No. EL/3.2.19 (G)

Modification Sheet No. RDSO/2017/EL/MS/0463 (Rev. '0') dated 08.09.2017

Provision of Trap Chamber for collecting coal/dust particles coming from BP pipe in A9 - BP circuit in conventional electric locomotives.

A-9 PORT NO.1 MODIFICATION

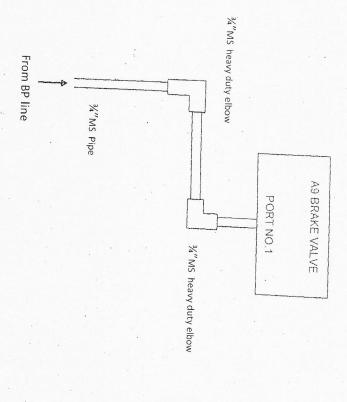
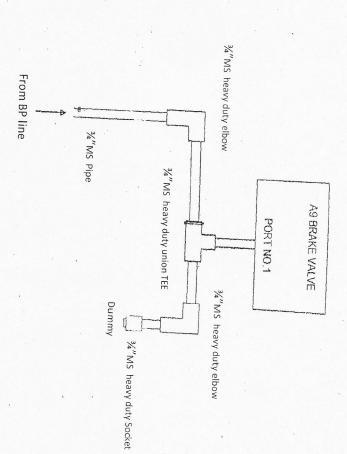
- 7.1 BP pipe line which is connected to A-9 is to be extended before A-9 and made dummy so that the coal or dust particles may be trapped in the chamber. Coal / dust particles entering from the BP pipe during emergency brake application would get accumulated in the trap chamber connected to the extended pipe due to moment of inertia and would not enter into the A-9 Valve. The arrangement of trap chamber is shown in figure under para 3.0. This arrangement should be made in both cabs.
- 7.2 Trap chamber is to be opened during every IC/AOH/TOH/IOH/POH schedules for cleaning or replacement if required.
- 8.0 Modification Drawing:
